Model type:
TAN2FR

Commercial code:
F035361

51420c0 Exploded views

51420C0

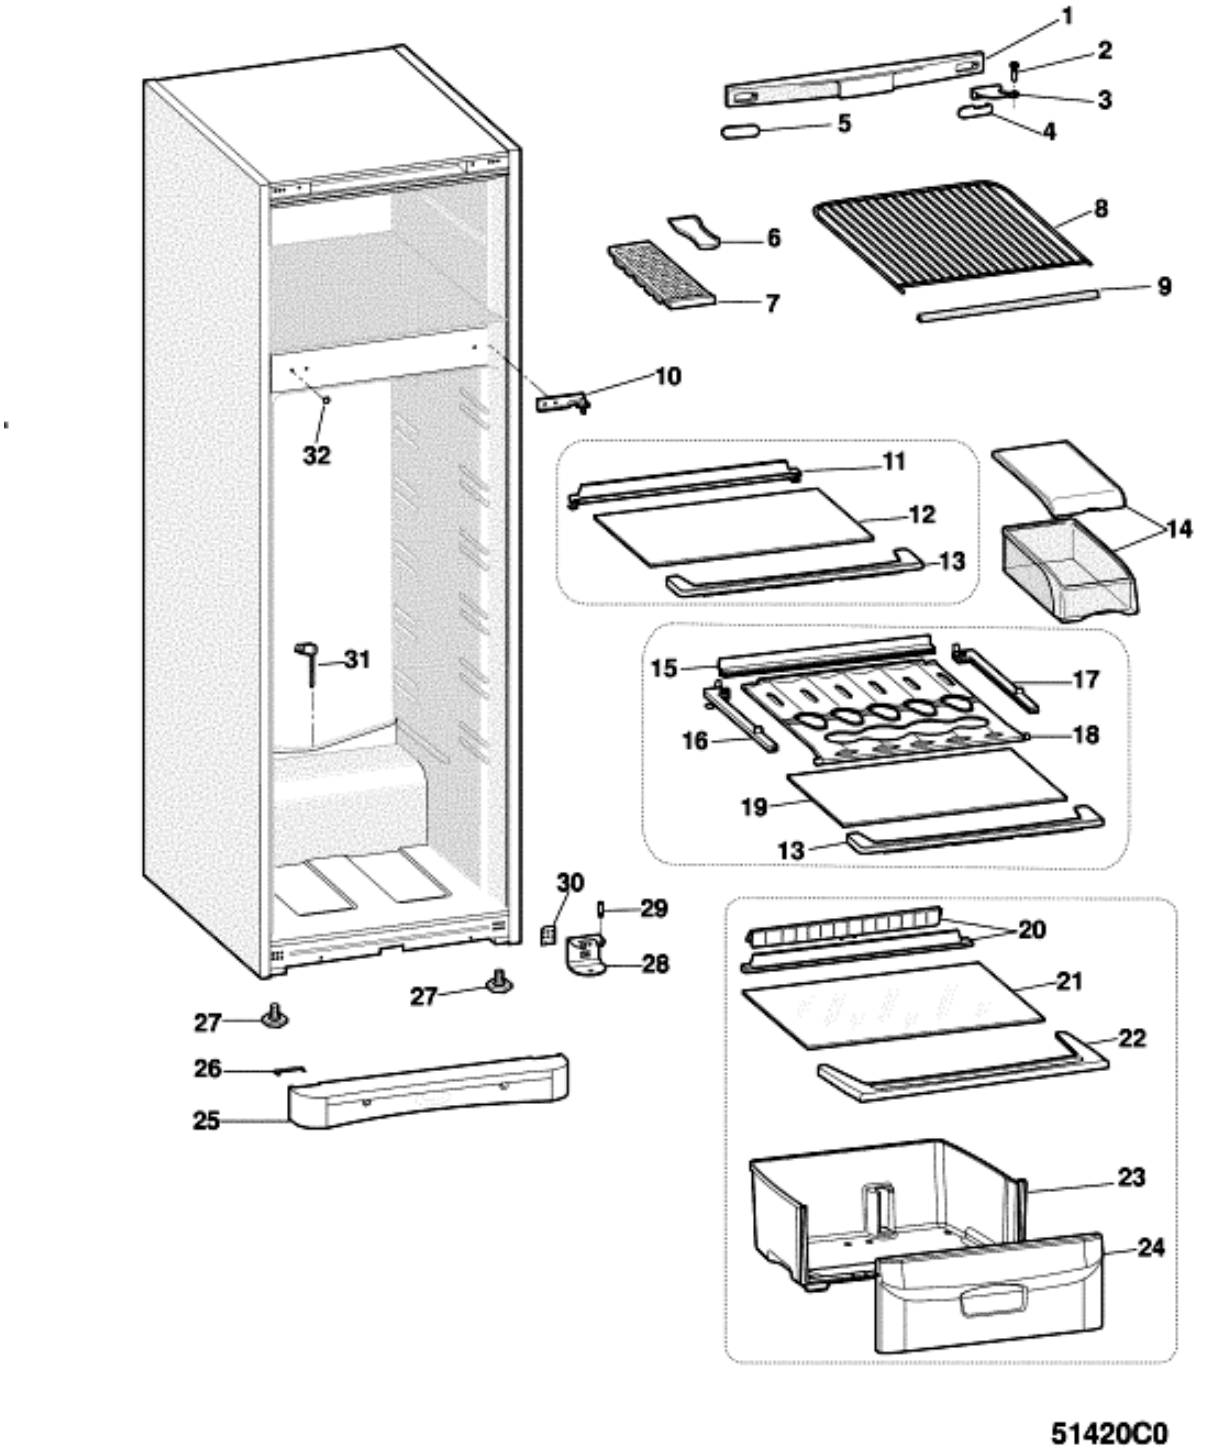
n2510j00: SUBSTITUTION LOWER HINGE PIN

In order to make better the assembly and to prevent an accidental unscrewing of lower hinge pin with consequent falling down of the door, original pin has been substituted by another one longer.

In the course of the time more than one pin has been tested, therefore the history of the substitutions is reported:

C00017658 (13.5mm) --> C00259768 (21mm) --> C00281425 (23mm)

For quality issues on interested models is managed only the last one C00281425 (23mm).

51421M0

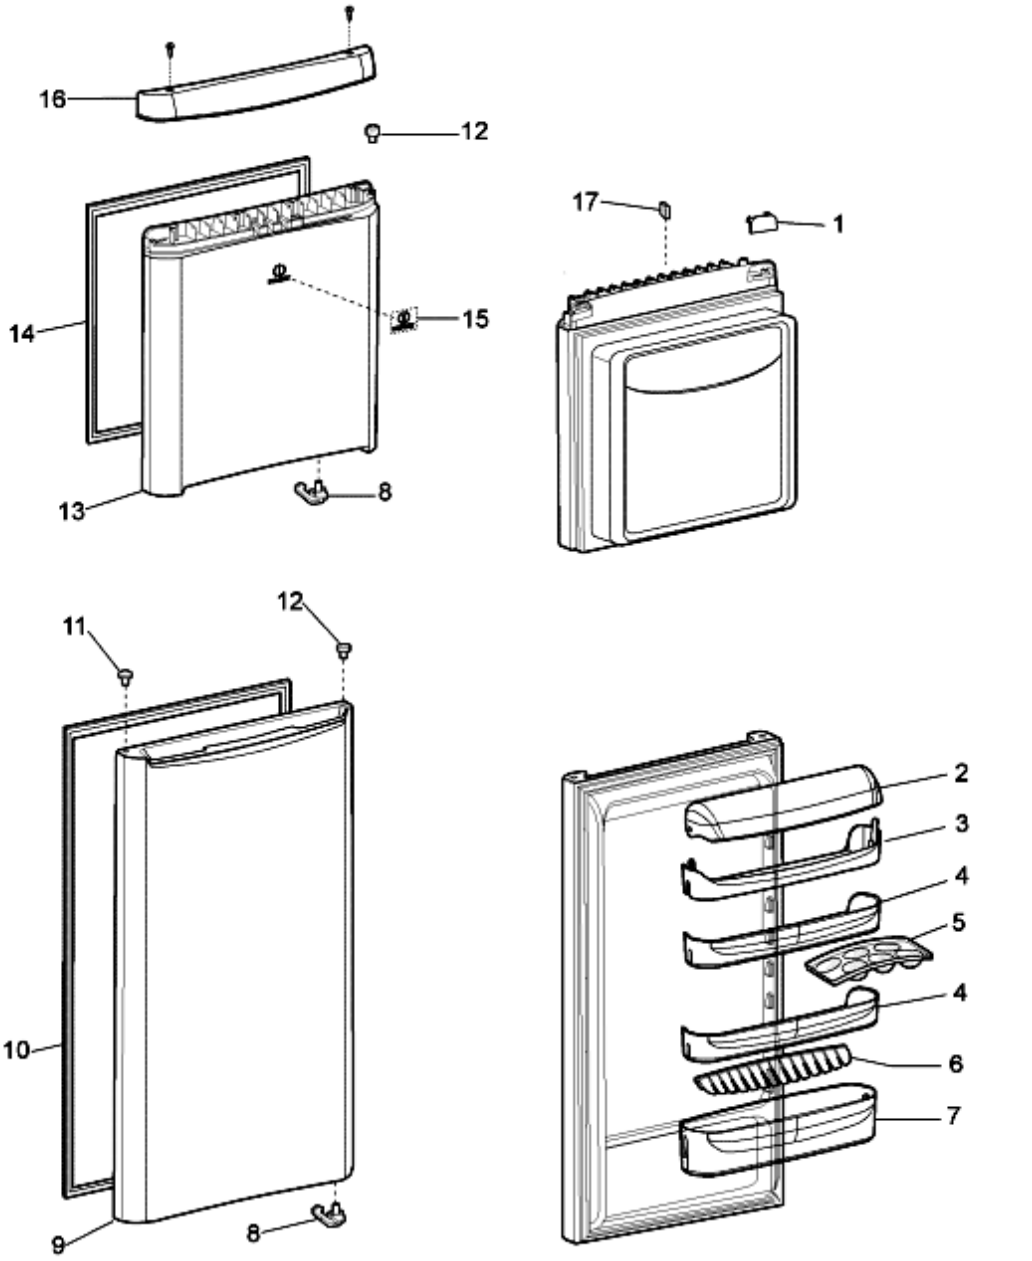
n2511b02: ELIMINATION COVER FOR UPPER DOOR SHELF-INTERNAL ACCESSORIES RESTYLING

Cover for upper door shelf has been eliminated. The upper door shelf has been standardized with the middle one. Subsequently has been standardized with transparent internal accessories instead of those in light blue colour once stock has depleted.

5142260 Exploded views

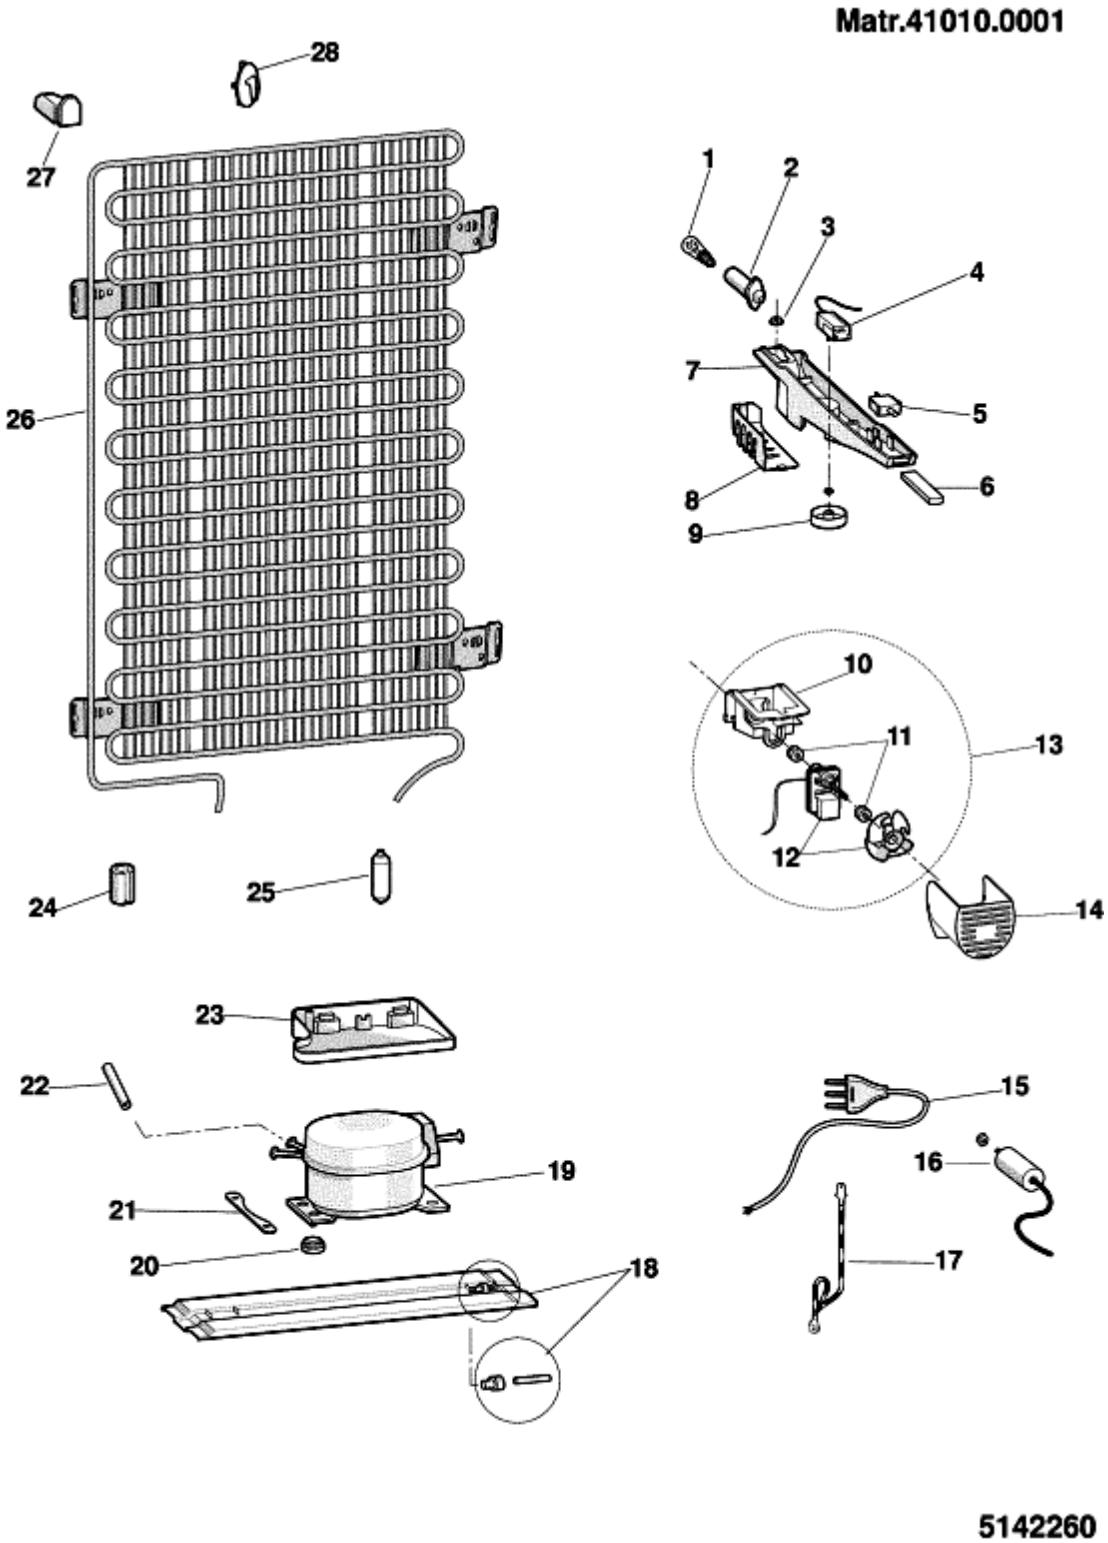
n1025101: Disappearing bulb thermostats (warning!)

The apparatus that provide for the thermostat to be threaded into a small tube located inside the fridge cabinet are noted as versions with "disappearing bulbs".
The bulb must be inserted for a length equal to the position indicated on the colored ribbon (small mark) which confirms the correct position of the bulb in the evaporation area, otherwise causing the poor performance of the apparatus.
Therefore in cases of thermostat replacement it will be necessary to reset on the new, if missing, the same small mark position and always check that the thermostat bulb is completely devoid of the sheath so as to ease its insertion.
The entrance of the small tube, placed in the thermostat container, is protected by a perforation cover in order to avoid the formation of condensation. The perforation cover was initially situated externally and could be substituted with putty or silicone.
For the models with disappearing bulb thermostats, the spare parts are inclusive of the small colored marker,

however check that its position corresponds to that on the thermostat that will be replaced.
The spare part description always notes the position of the small marker in millimeters as well as the thermostat initials.

n1025135: Thermostat box on Indesit/Ariston Opera-60 refrigerators (low A.T. +16°C)

As of July 2003, two new "Low ambient temperature thermostat box kits" have been introduced as spare parts for Ariston Opera-60 and Indesit 2000 - 2002 - 2003 range refrigerators with Giugiaro thermostat box (075646).

The kit must only be used to solve freezer performance problems caused by an ambient temperature below +16° C.
This innovative kit features a DIODE, activated by means of the luminous switch, which makes the thermostat box lamp turn on.
It must be activated when the ambient temperature falls below +13°C (closed contacts: see the wiring diagram that comes with the kit).
The heat produced by the lamp activates the thermostat, thus ensuring regular operation of the appliance.
When replacing the thermostat box, no component can be reused (including the wiring).
The kit wiring has pin terminals for connection to the terminal block on the compressor; some modifications may be required for other solutions.
Given below is the list of kit items available as spare parts:
